EDINBURG CISD

ADDENDUM 3
CSP 23-02
UTRGV-EDINBURG CISD COLLEGIATE HIGH SCHOOL
October 3, 2022

This addendum is issued for the purpose of modifying the plans and specifications for the *UTRG/EDINBURG CISD COLLEGIATE HIGH SCHOOL*.

Date: September 9, 2022
Scale: As Noted
Project Architect: David Monreal, AIA
Drawn By: JA, CM, CG
Job No.: UTRGV/CISD
Sheet: A2.03

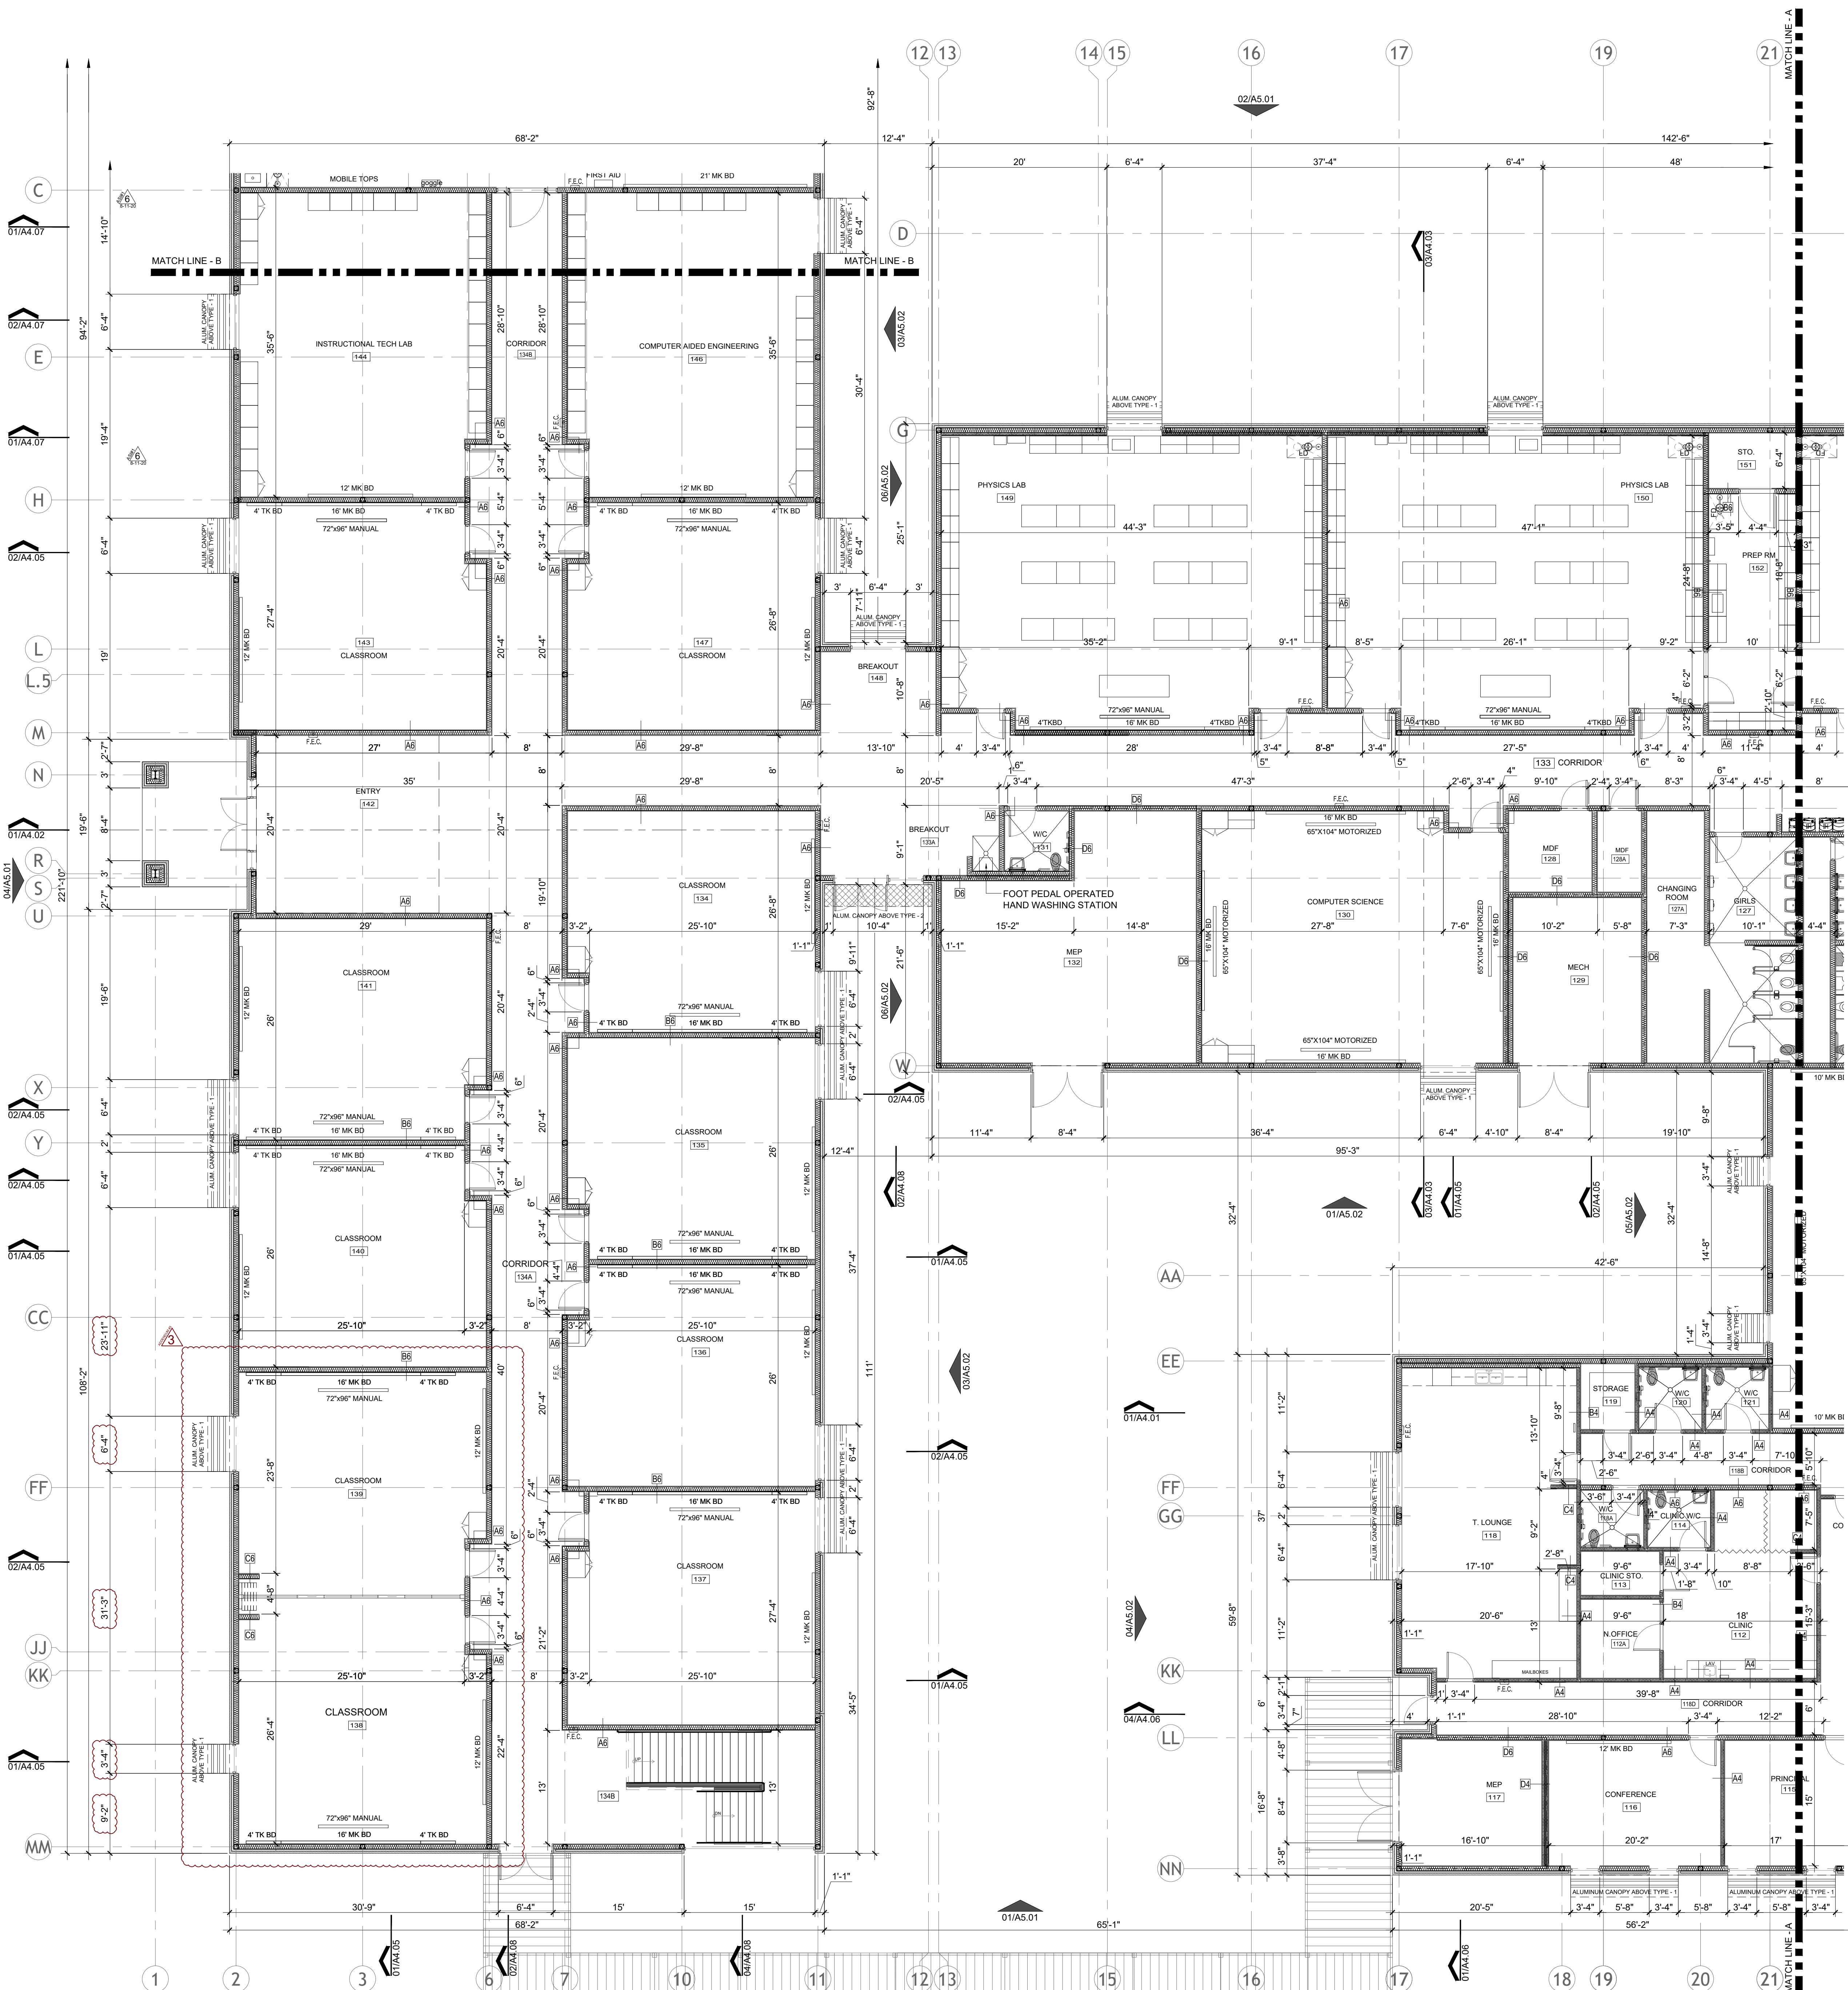
1. Sheet A2.01
 - a. Add Operable Partition
 - b. Revise window locations and dimensions to accommodate operable partition.
2. Sheet A2.03
 - a. Add Operable Partition

- b. Revise window locations and dimensions to accommodate operable partition.
3. Sheet A2.04
 - a. Add Operable Partition
 - b. Revise window locations and dimensions to accommodate operable partition.

Date: September 9, 2022
Scale: As Noted
Project Architect: David Monreal, AIA
Drawn By: JA, CM, CG
Job No: UTRGV/CISD
Sheet: A2.06

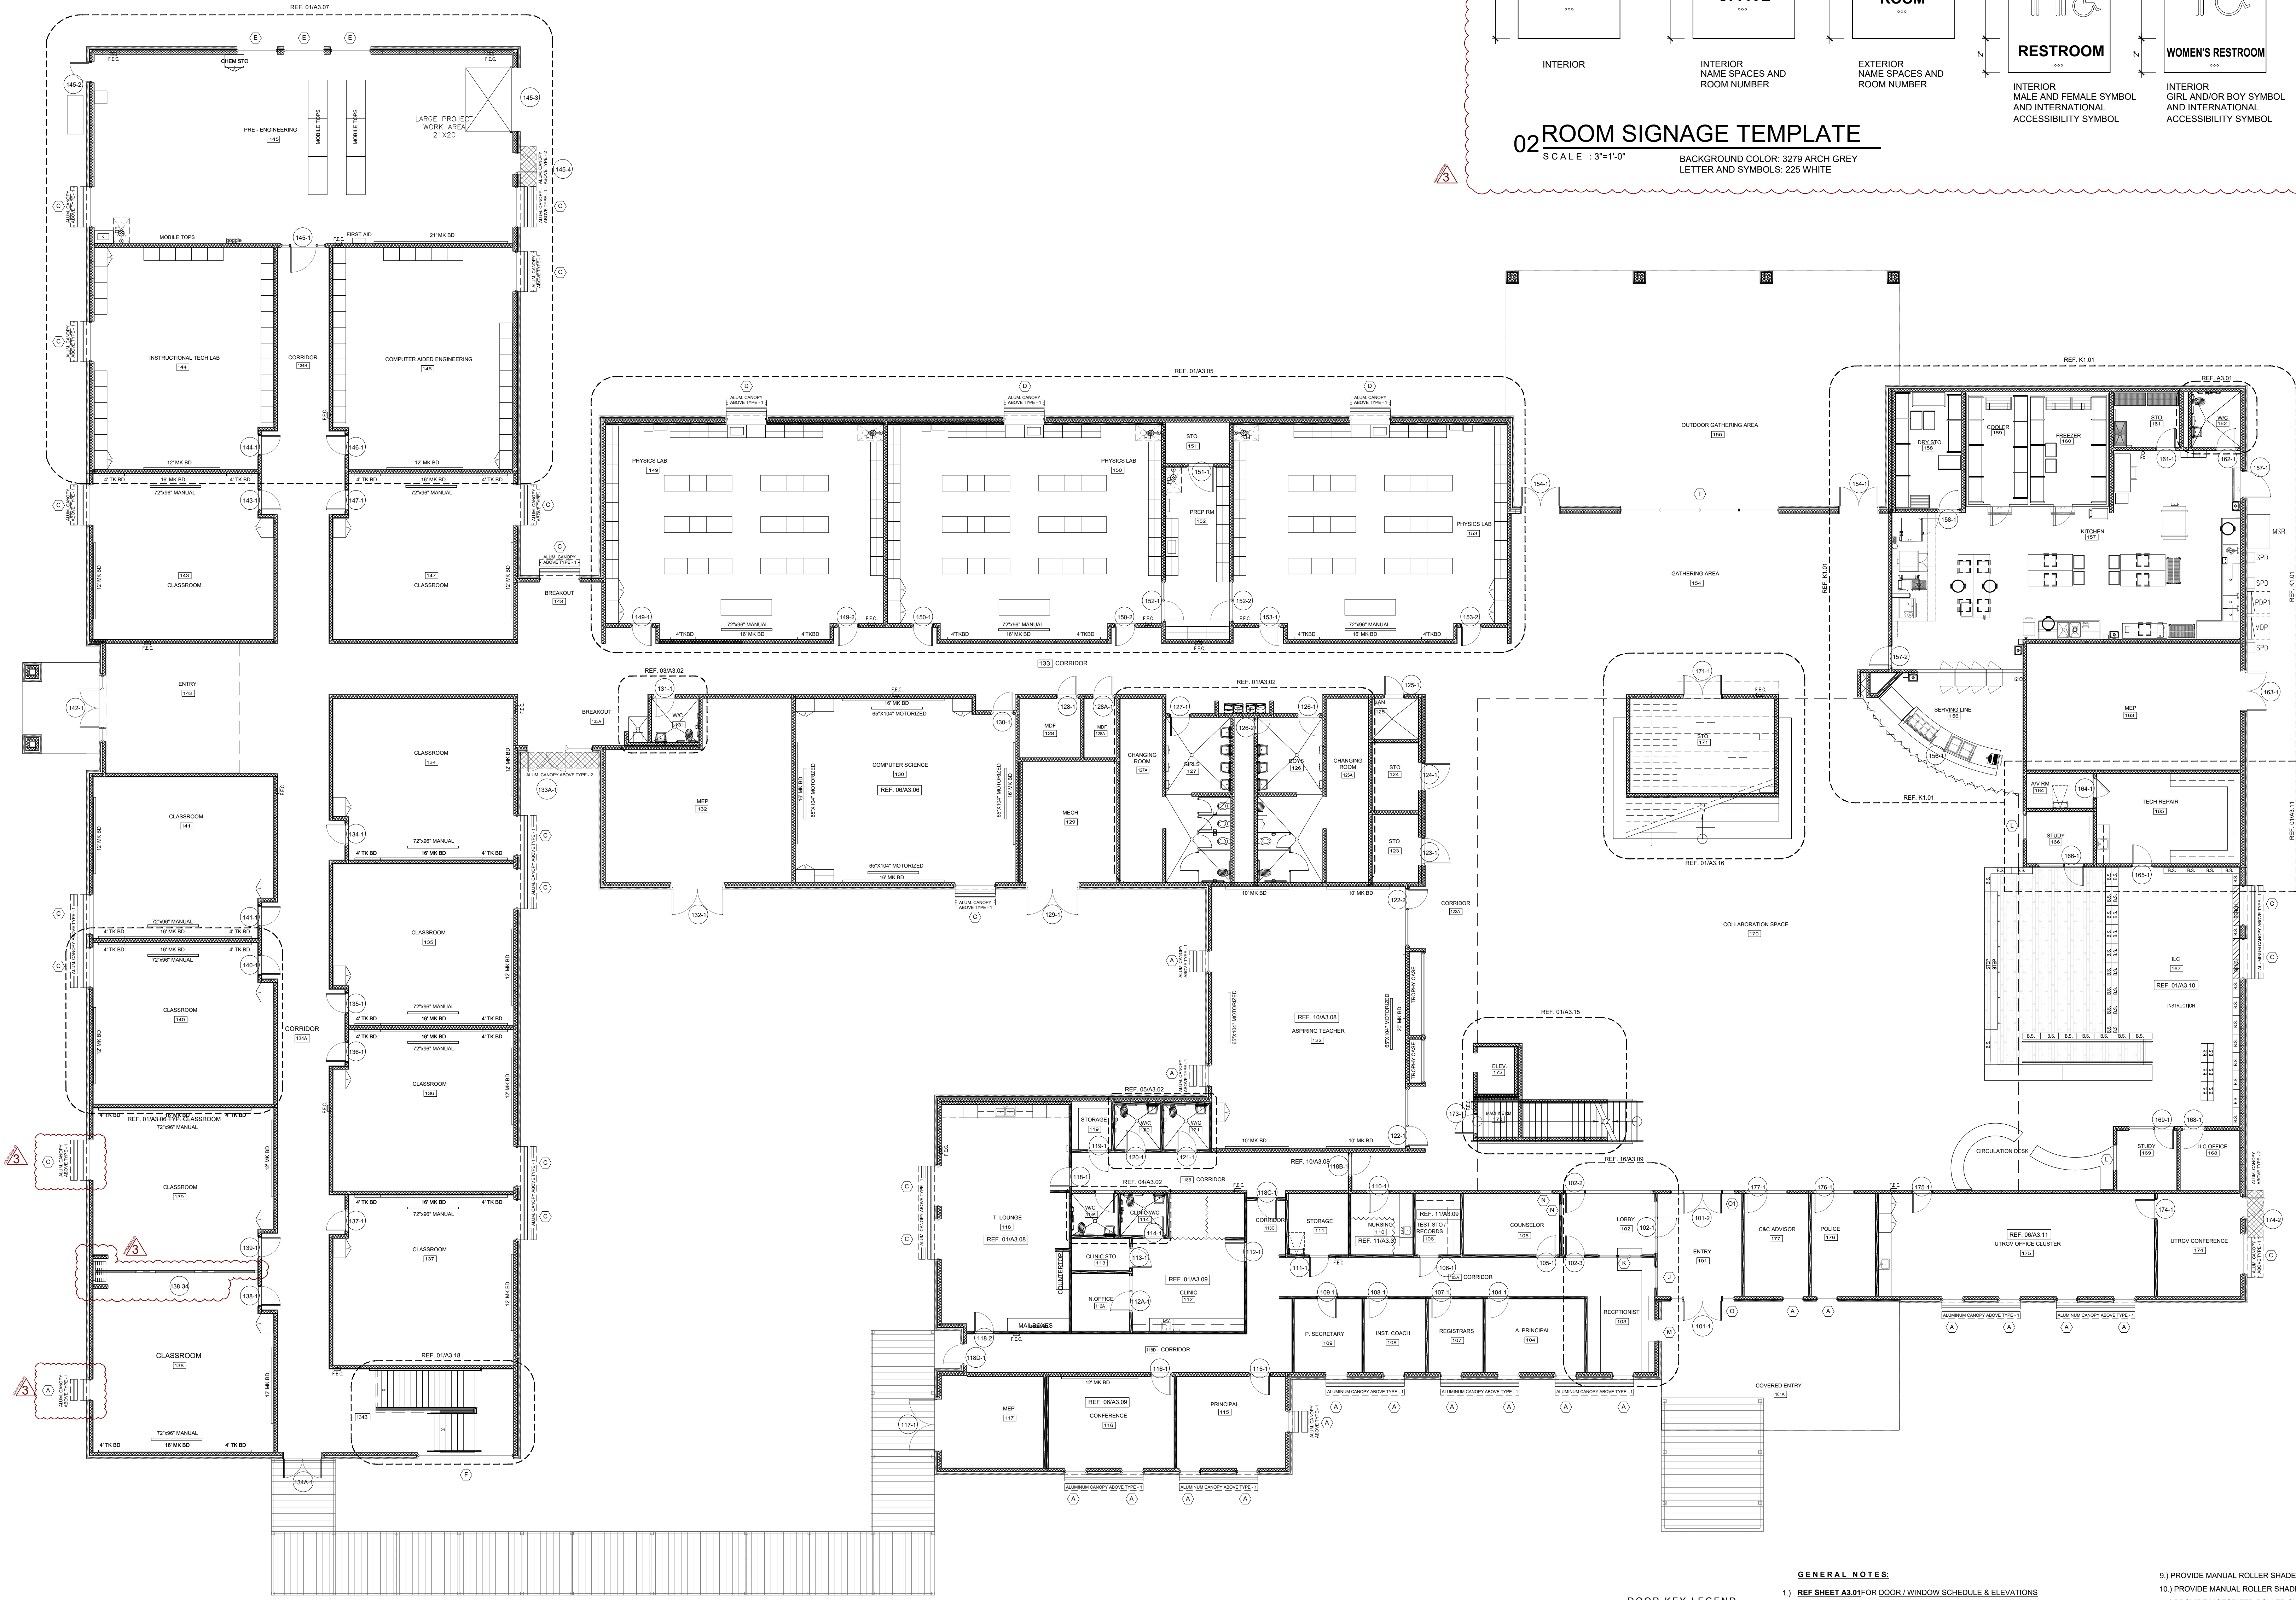
4. Sheet A2.06
 - a. Add Operable Partition
 - b. Revise window locations and dimensions to accommodate operable partition.
5. Sheet A2.07
 - a. Add Operable Partition door type designation.
